Tender for " Construction of Smt. INDRANI BALAN Science Activity Centre at IISER PUNE, MAHARASHTRA." NIT Number: 26/IISER/PUNE/2017-18 **Date of Issue : 13.11 2017**

MINUTES OF PRE-BID MEETING

Pre bid Meeting Held at Office of IISER-Pune on 13 November, 2017 at 11.00hrs

POWER SCHEMATIC FOR
IISER,PASHAN

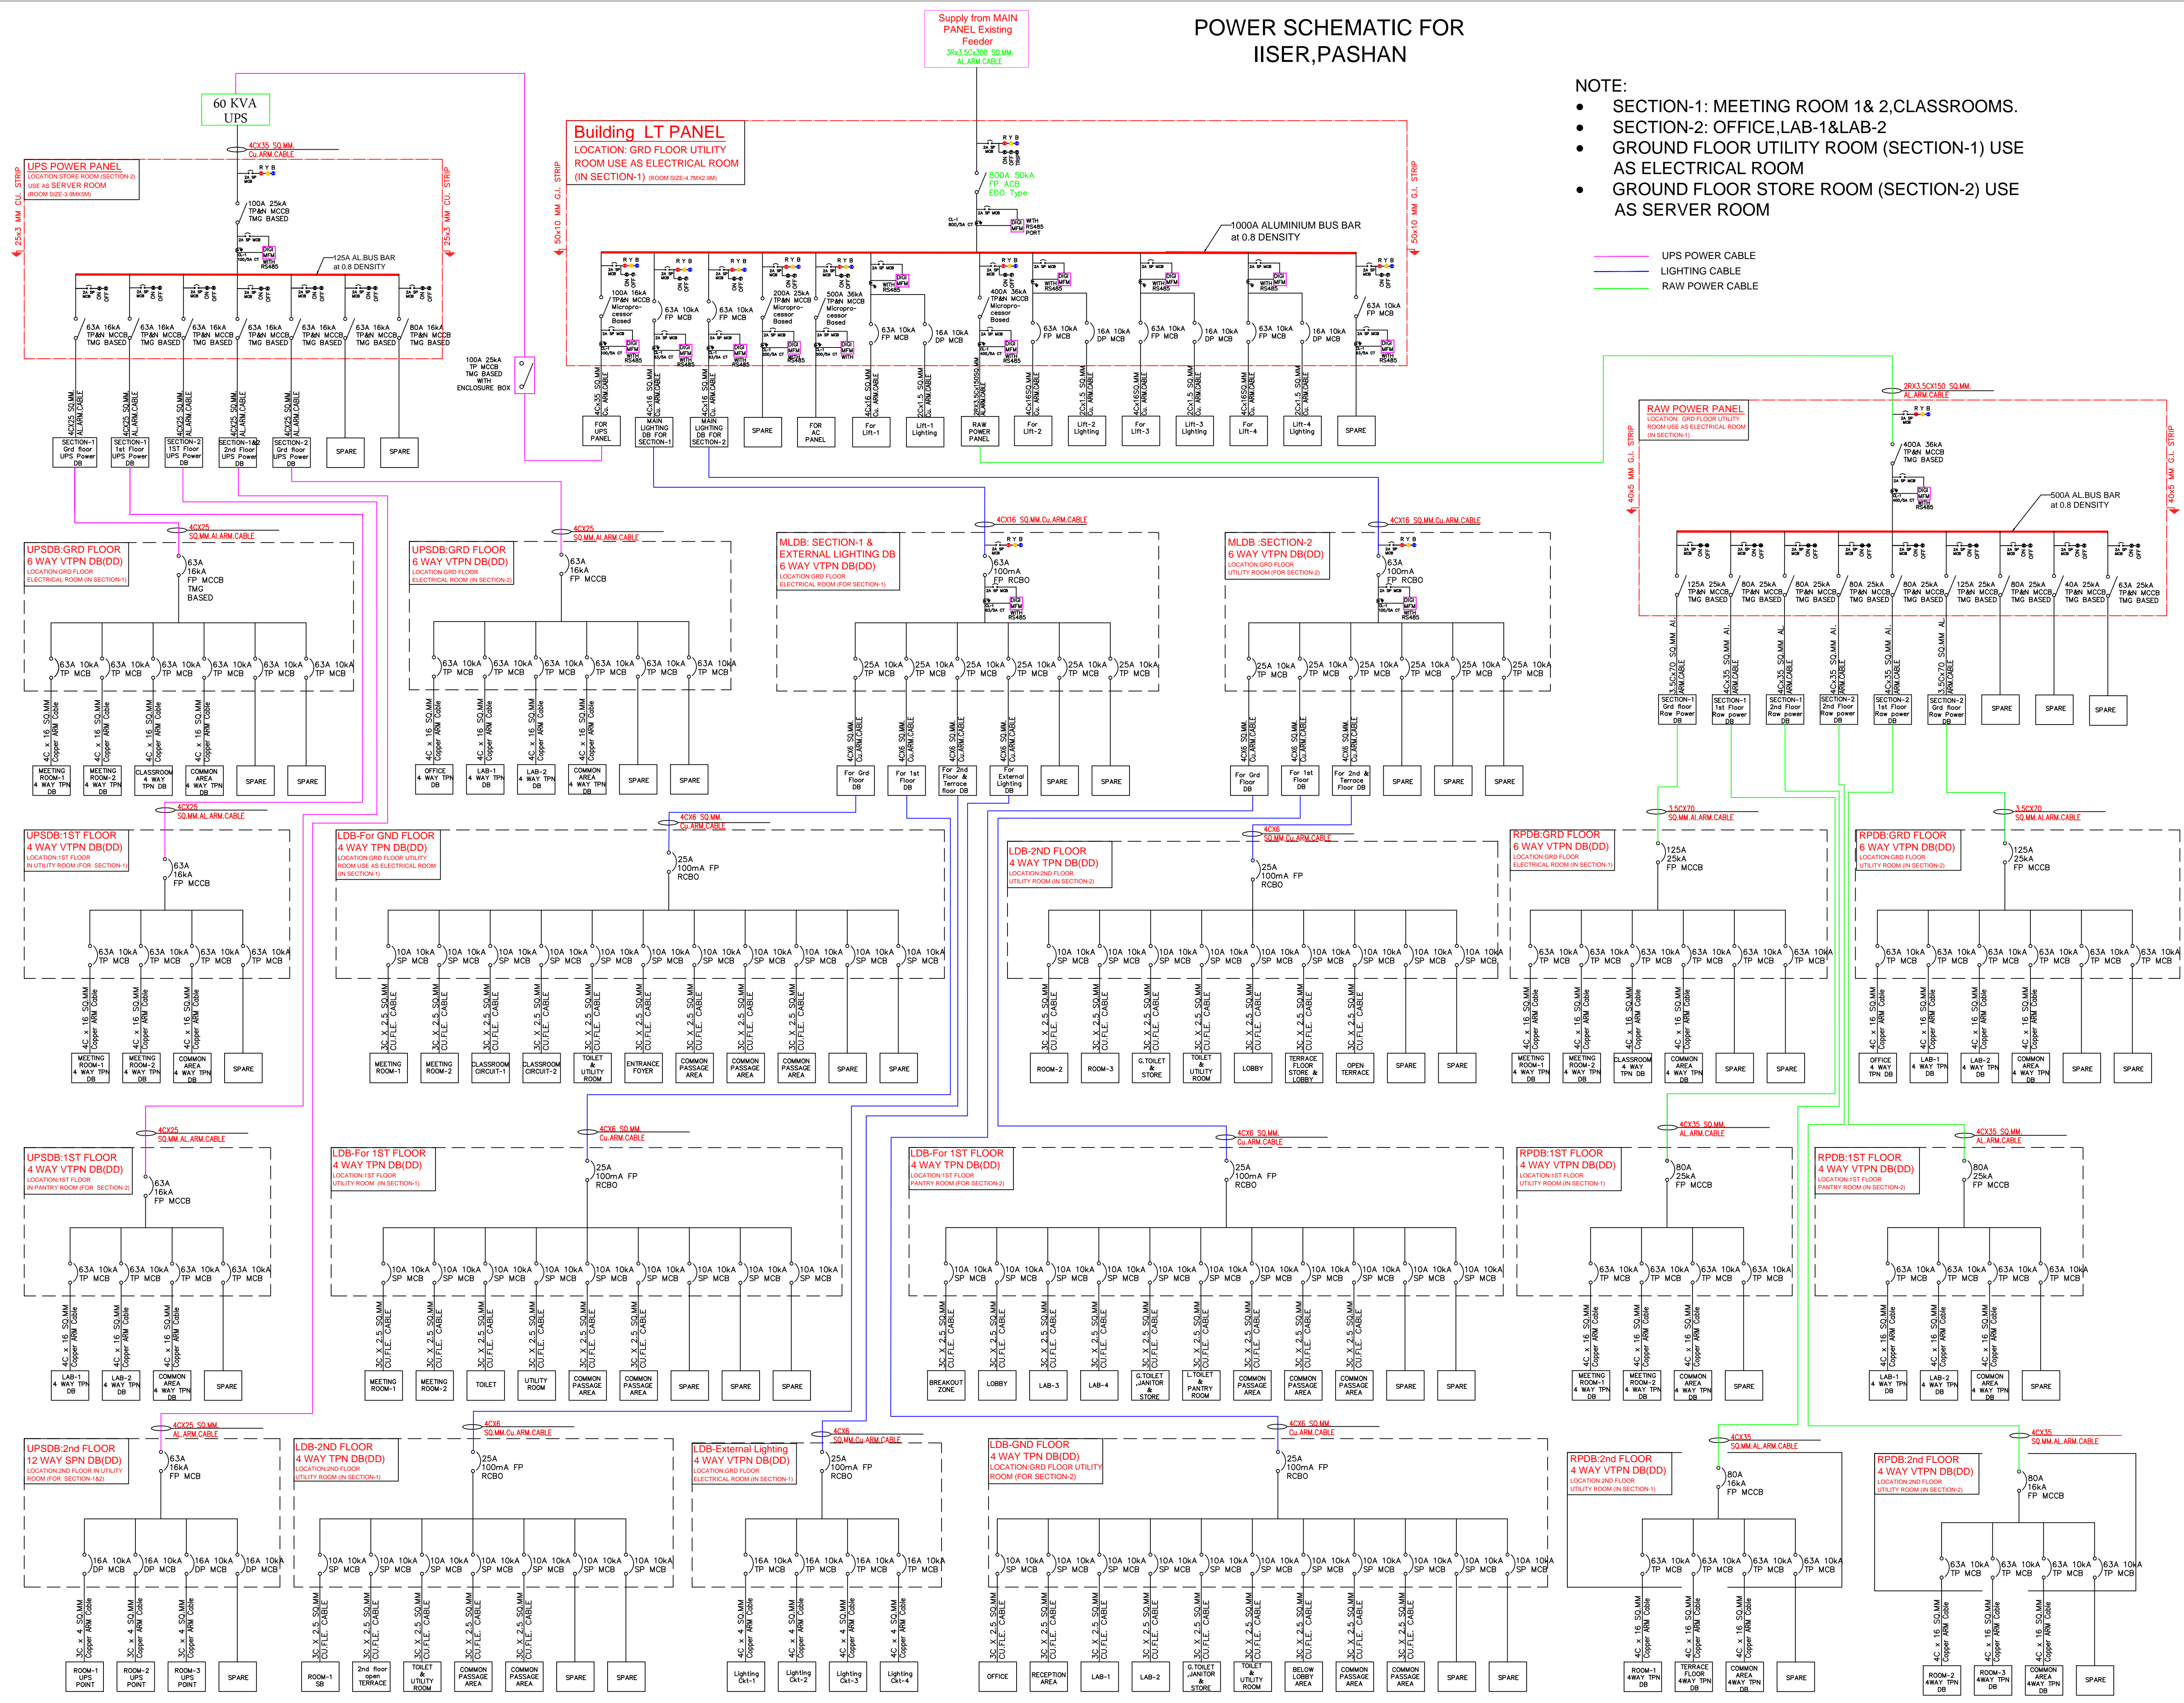
Sr. No.	Ref. to NIT/ BOQ	Point Discussed	IISER Clarification
1	NIT Clause 2(b)	Turnover we have to consider consecutive year from 1) 2013-14; 2)2014-15; 3) 2015-16?	Turnover for immediate last three consecutive financial year ending 31 st March 2017
2	General	Needs structural drawing for study of the connections with RCC slab/Deck slab of class room.	Deck slab rest on M S Truss fixed on RCC column with holding down bolts. Item rate tender hence quote as per BOQ.
3	General	Requires Auto cad drawing to workout areas required for estimation purpose.	Item rate tender, hence quote as per BOQ item.
4	BOQ item no. 3.3	Masonry Work : For masonry work we want to explore the possibility of use of ACC block instead of Fly ash bricks instead of fly ash bricks for 100mm thick which helps in speedy construction as well as if fixed with chemical mortar needs very less curing helps saving in water.	No change in BOQ item.
